FLORIDA POWER AND LIGHT COMPANY  
DOCKET NO. 50-250  
TURKEY POINT NUCLEAR GENERATING STATION UNIT NO. 3  
AMENDMENT TO FACILITY OPERATING LICENSE

Amendment No. 37  
License No. DPR-31

ATTACHMENT TO LICENSE AMENDMENT NO. 37  
TO THE TECHNICAL SPECIFICATIONS  
FACILITY OPERATING LICENSE NO. DPR-31  
DOCKET NO. 50-250

SAFETY EVALUATION BY THE OFFICE OF NUCLEAR REACTOR REGULATION

Figure TS 2.1-1b  
Amendment Nos. 37 & 31

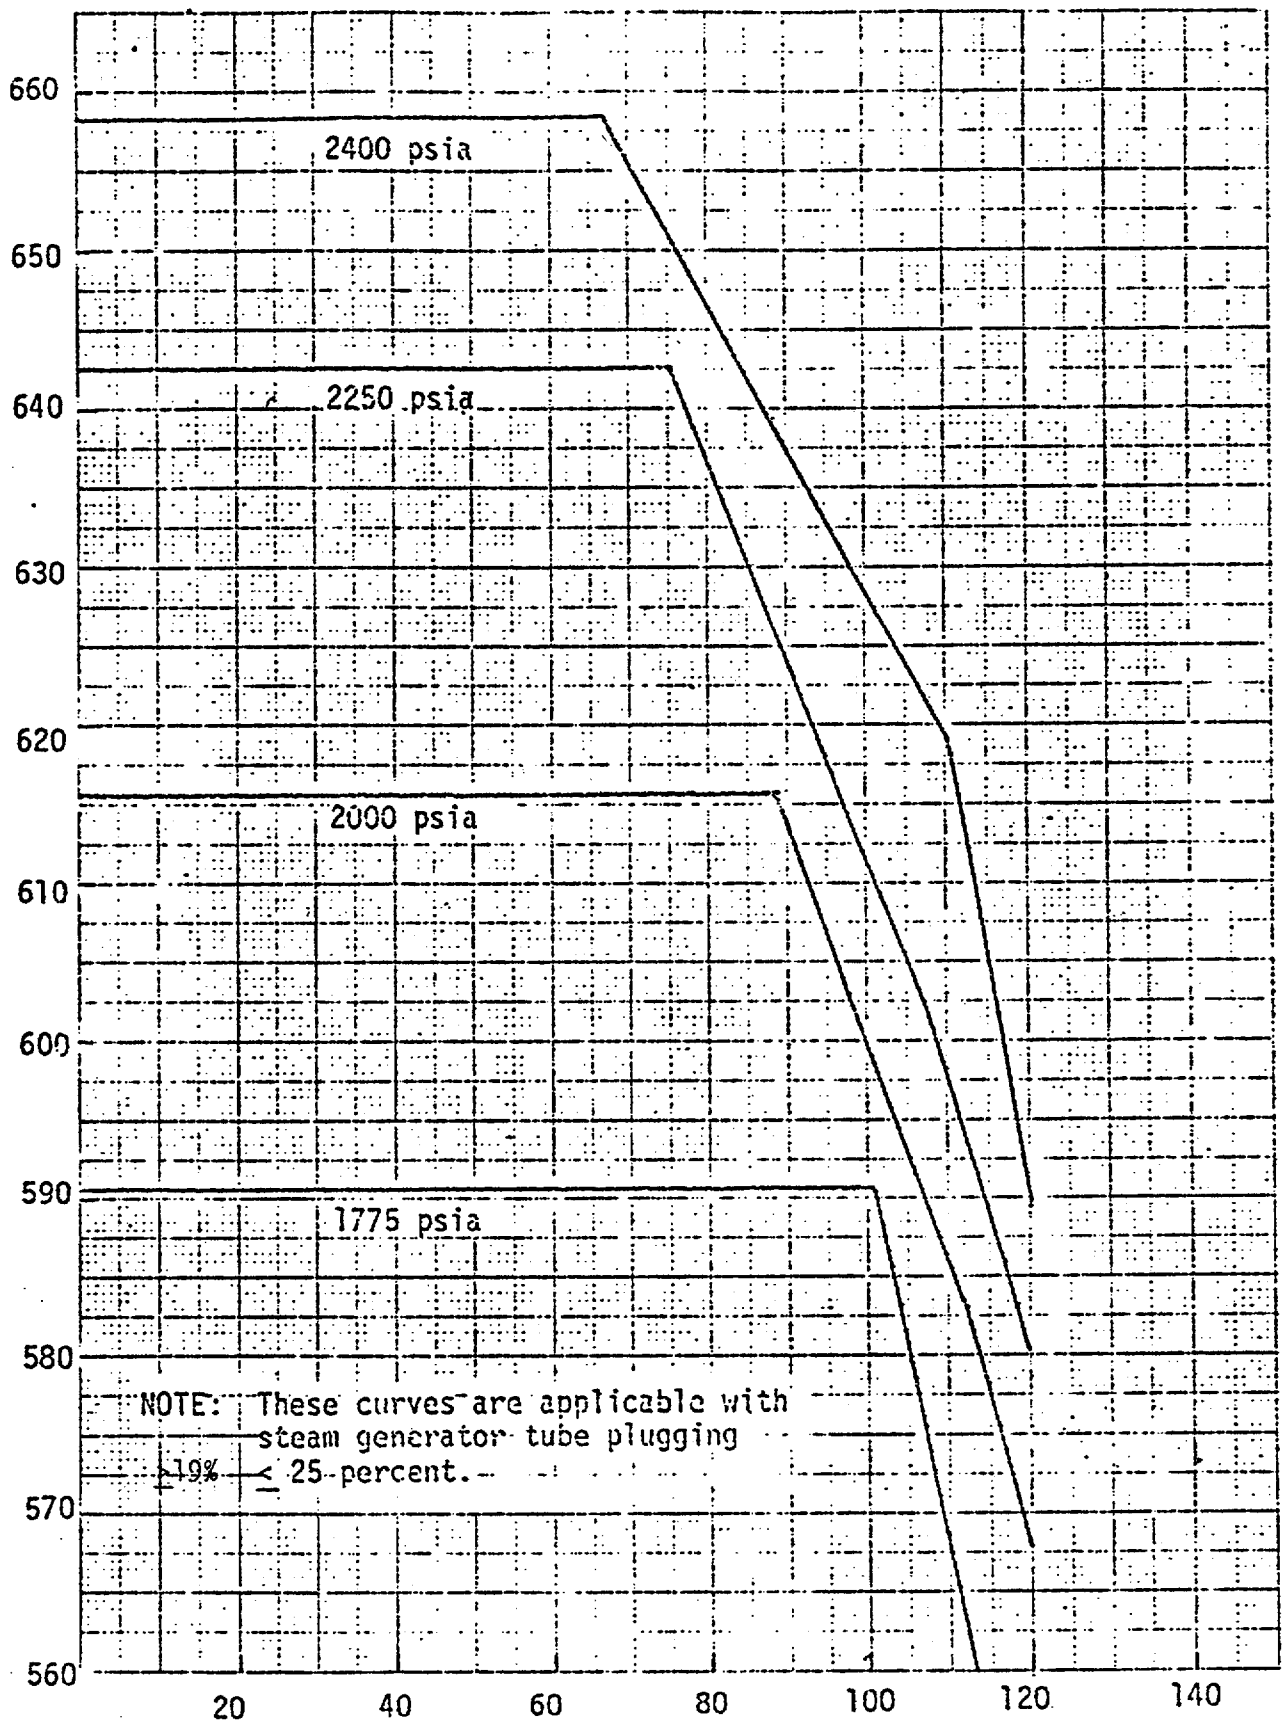
1. Add a figure defining the safety limits for 3 loop operation with between 19 and 25 percent of the steam generator tubes plugged.
2. Change the overpower  $\Delta T$  trip function constants consistent with the above safety limits.
3. Reduce the reactor coolant flow rate to 255,075 gpm (95% of former value).
4. Change the total core peaking factor,  $F_Q$  to 2.03.
5. Revise the axial  $F_Q$  shaping factor figure to reflect a renormalization of the new (large break) LOCA analysis with the existing function.

The overtemperature equation constants were recalculated consistent with the new Core Thermal and Hydraulic Safety Limits (T. S. Figure 2.1-1b) and compared to the FSAR values. The FSAR values were shown to be more limiting due to the higher  $F_{\Delta H}^N$  which was used for the original Core Thermal Limits. To offset the effects of the RCS flow reduction, the FSAR overtemperature  $\Delta T$  trip constants will be maintained in the Technical Specifications (page 2.3-2). By using these same setpoints, the reduction in DNBR during the transient would be approximately the same. Thus the minimum DNBR for the 25% steam generator tube plugging case is expected to be greater than the FSAR value since the initial steady state DNBR has increased.

Figure 2.1-1b, "Reactor Core Thermal and Hydraulic Safety Limits, 3 Loop Operation" has been added to the Technical Specifications for operation with between 19 and 25 percent of the steam generator tubes plugged. These limits were generated by Westinghouse and are consistent with the limits for lower levels of plugging.

FIGURE 3.2-3

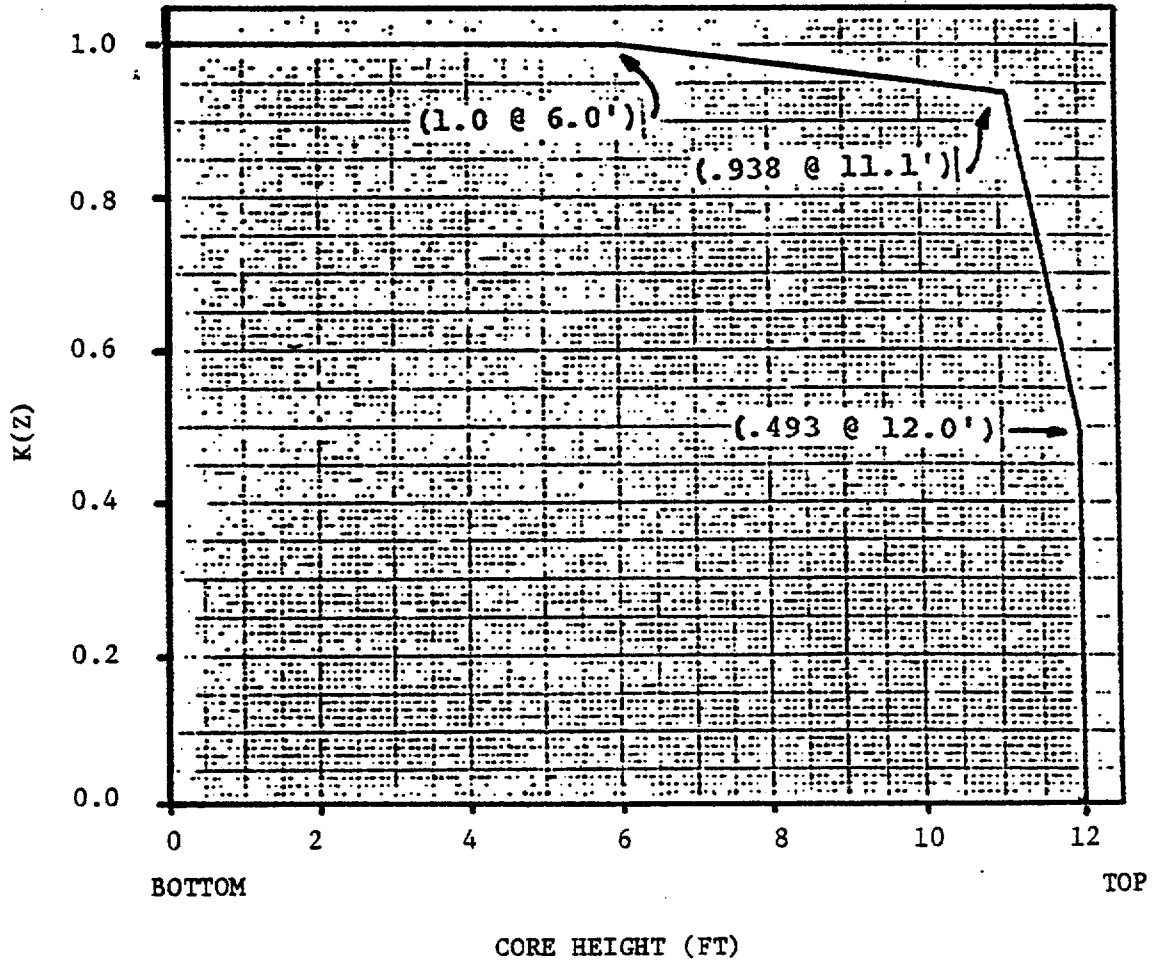
The normalized axial  $F_Q$  shaping factor (Figure 3.2-3) in the Technical Specifications has been changed consistent with the assumptions used as input for the LOCA analysis.

Where P is the fraction of rated power at which the core is operating; K(Z) is the function given in Figure 3.2-3; Z is the core height location of  $F_q$ .

The technical specifications on power distribution control assure that the  $F_q$  upper bound envelope as defined by Figure 3.2-3 is not exceeded and xenon distributions are not developed which at a later time, would cause greater local power peaking even though the flux difference is then within the limits specified by the procedure.
